**LEVY NUCLEAR PLANT, UNITS 1 AND 2  
DOCKET NOS. 52-029 AND 52-030  
SUPPLEMENT 1 TO RESPONSE TO REQUEST FOR ADDITIONAL INFORMATION LETTER  
NO. 055 RELATED TO FOUNDATIONS**

**Levy Nuclear Plant Units 1 and 2  
Supplement 1 to Response to NRC Request for Additional Information Letter No. 055  
Related to SRP Section 3.8.5 for the Combined License Application,  
Dated June 9, 2009**

**NRC RAI NUMBER:** 03.08.05-3

**PGN RAI ID #: L-0699**

Figure RAI 03.08.05-03-1 Rev 1

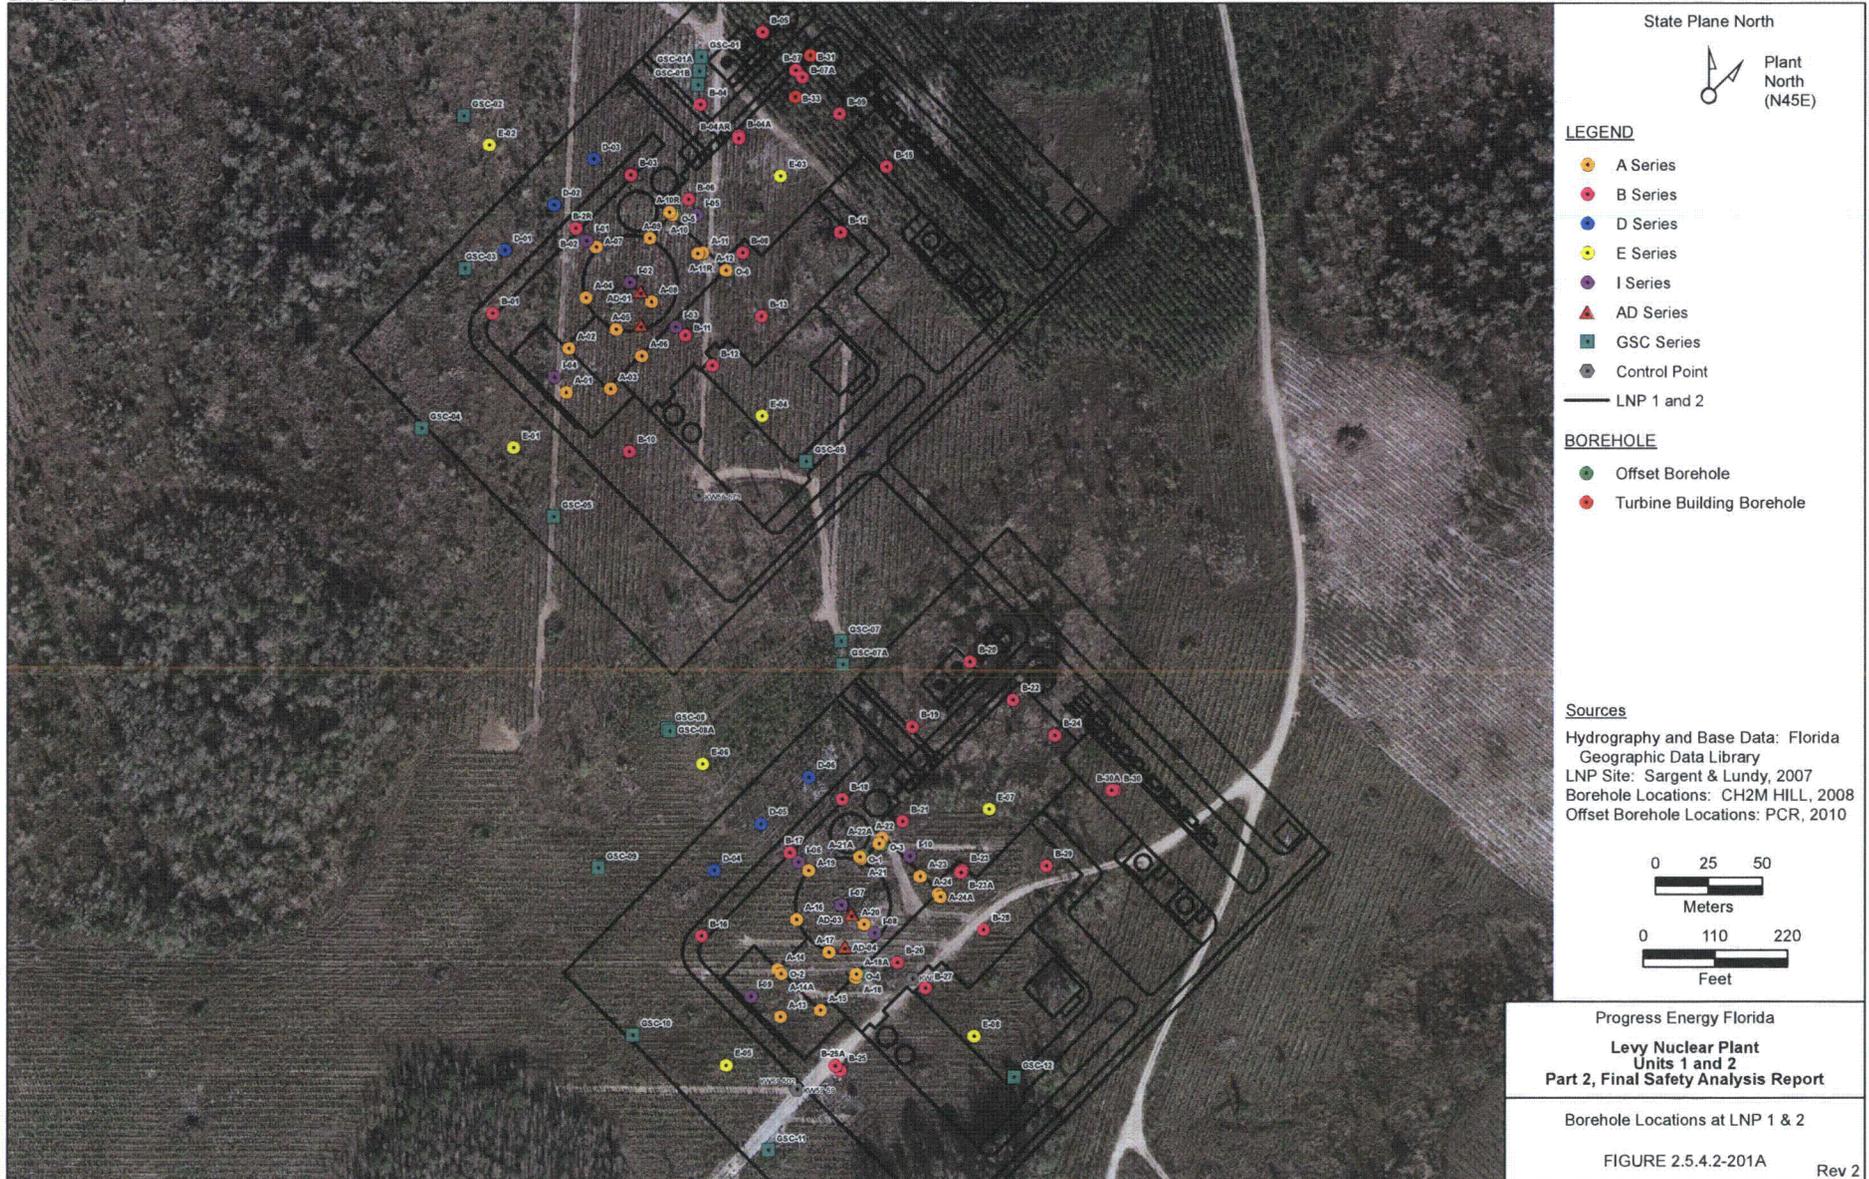
Zones of liquefied soil may reduce effective foundation stiffness for earthquake conditions even if they are isolated. This softening effect would depend in part on the extent and distribution of liquefiable soil. A concern is that the softening may produce horizontal seismic displacements that exceed the gaps between buildings, either above ground (4 inch minimum gap) or at the foundation level (2 inch minimum gap).

Please provide more detail on how liquefaction potential has been addressed in the existing seismic interaction calculations:

“For borings where the liquefaction analysis shows potential for liquefaction, the borehole identification, bottom depth of the SPT sample, soil type, and the field SPT N-Value used in the liquefaction analysis are summarized in revised Tables 2.5.4.8-202A and 2.5.4.8-202B. The revised Tables 2.5.4.8-202A and 2.5.4.8-202B also present the results of the liquefaction analysis including the factors of safety against liquefaction and the depth of the postulated liquefiable zone. Figures RAI 03.08.05-03-1 Rev.1 and RAI 03.08.05-03-2 Rev. 1 show, in plan and elevation respectively, the location of the liquefaction zones identified in revised Table 2.5.4.8-202A for LNP Unit 1. Figure RAI 03.08.05-03-3 Rev.1 and Figure RAI 03.08.05-03-4 Rev. 1 show, in plan and elevation view respectively, the liquefaction zones identified in revised

Table 2.5.4.8-202B for LNP Unit 2. In these figures the liquefaction zones with a factor of safety of less than or equal to 1.1 are shown by circles with yellow infill. For Unit 1, liquefiable zones were postulated in boreholes O-2, A-15, A-18/O-4, and B-28. Boreholes O-2, A-15 and A-18/O-4 are in the nuclear island excavation zone. Borehole B-28 is under the Annex Building. For Unit 2, liquefiable zones were postulated for boreholes B-01, B-07, B-07A, B-31, and B-33. Borehole B-01 with liquefiable zones is well away from the AP1000 footprint. Boreholes B-07, B-07A, B-31, and B-33 are under the Turbine Building. Based on these figures, it was concluded that liquefiable zones under the LNP Units 1 and 2 footprints are confined to the northwest corner of the Unit 2 Turbine Building and in isolated random pockets under the remaining LNP Units 1 and 2 footprints.

Turbine Building Subgrade  
 Figure RAI 03.08.05-03-5  
 Rev 0

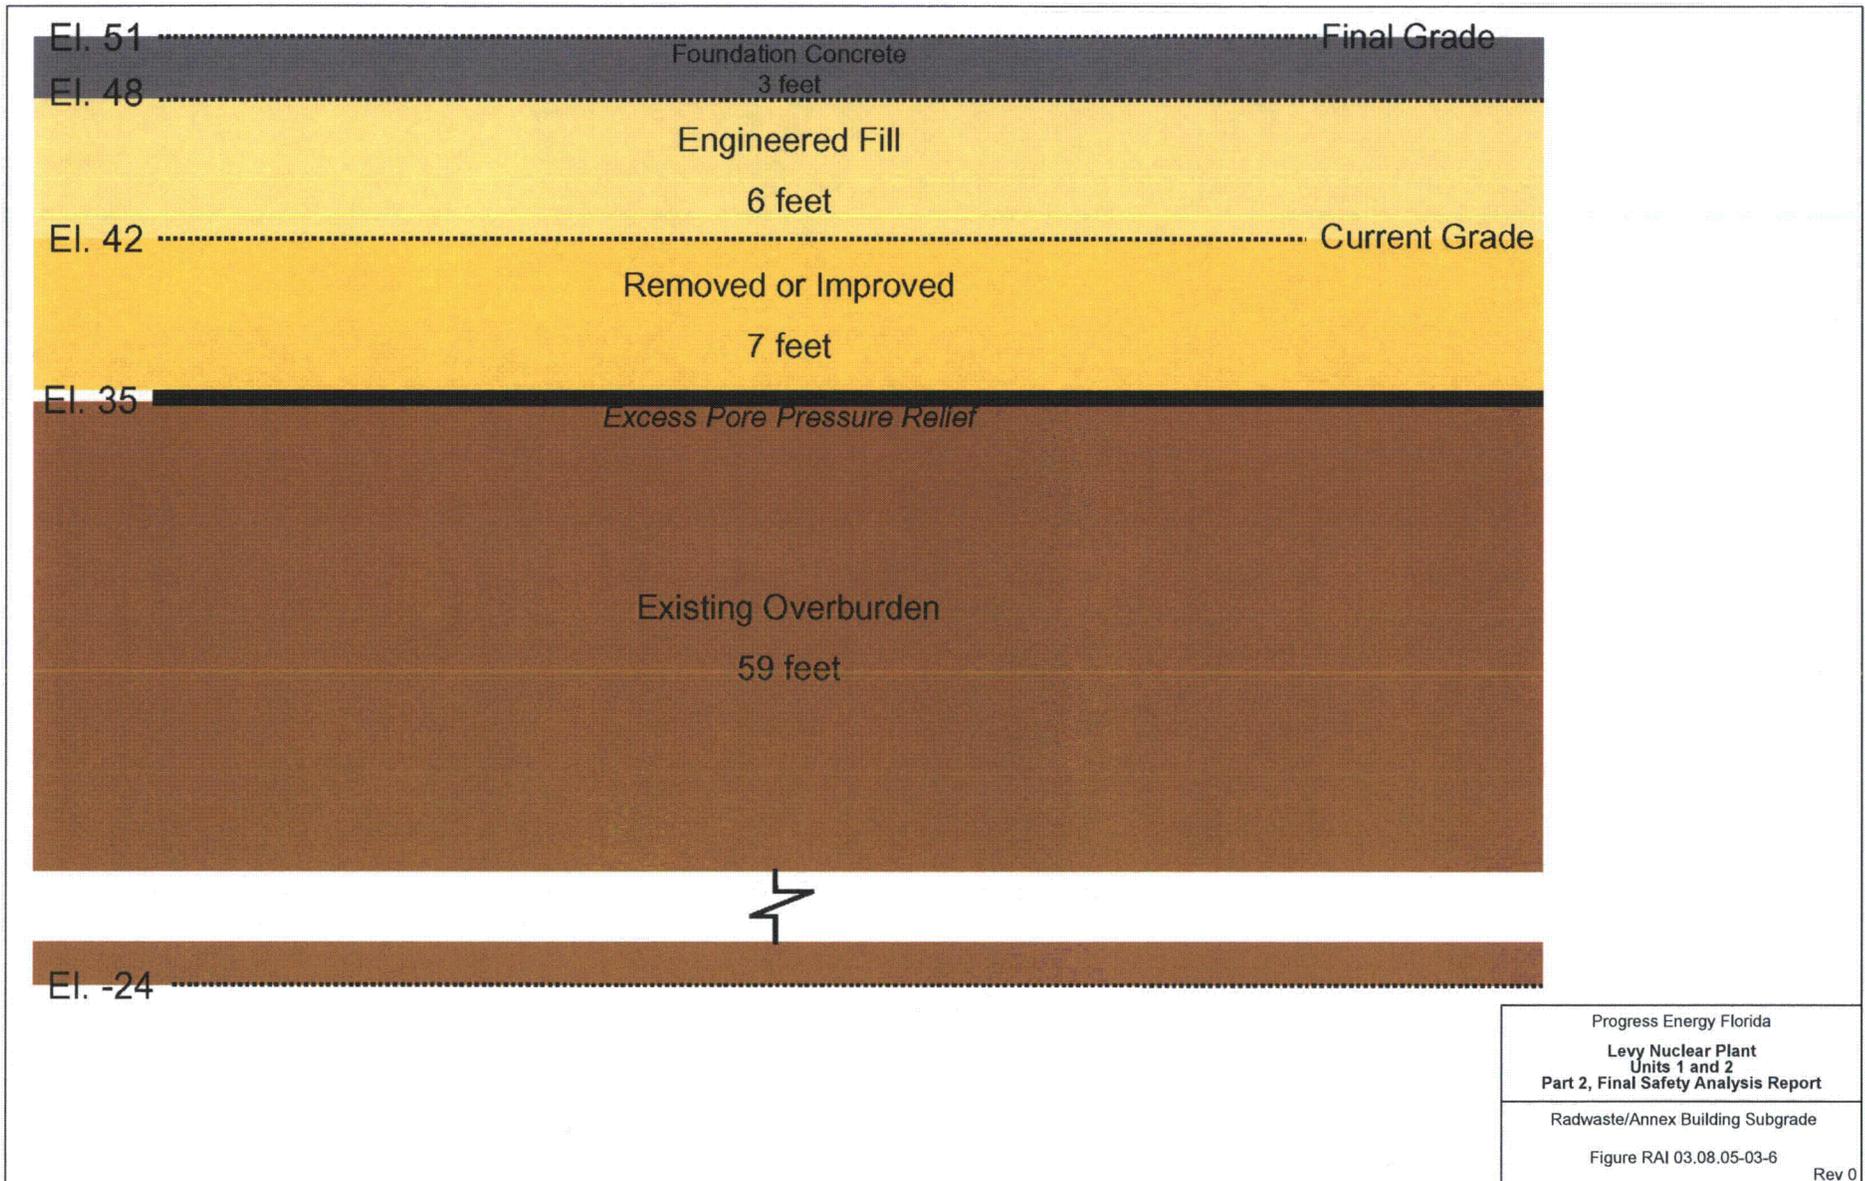
4. With regard to liquefaction, what soil data will be recorded during pile test boring and how will this data be used to verify the seismic interaction analyses?

5. Please identify if pile seismic design will rely on lateral bearing on soil and how potential zones of liquefaction will affect the pile stiffness. Also, does the 7 foot depth of engineered fill (FSAR Section 2.5.4.8.1) account for required pile stiffness?
6. If pile seismic design will not rely on the upper soil layers as a load path, please demonstrate that a practical stiffening design can be achieved by moment frame action given the length of the piles.
7. Will the use of battered piles be considered as a design method?

4. As stated earlier in the response, no additional liquefaction evaluation or soil remediation for Annex, Radwaste Building, and Turbine Building foundation is necessary. The only exception is in the northwest (plant coordinates) corner area of Unit 2 Turbine Building condenser pit. In this area, as stated in paragraph 2 above, the earthwork design will incorporate provisions to prevent buildup of excess pore pressures that cause liquefaction within the 16 ft. depth required for lateral support.

5. The seismic interaction analysis of calculation LNG-0000-XCC-002 Revision 1 relies on the lateral bearing on soils including the engineered fill and improved soils. The engineered fill and improved soils extend from elevation approximately 10.7 m (35 ft.) to the plant design grade elevation 15.5 m (51 ft.). As stated in paragraph 2 above, in the northwest corner of the Unit 2 Turbine Building condenser pit earthwork design will incorporate provisions to prevent buildup of excess pore pressures that cause liquefaction within the 16 ft. depth required for lateral support.
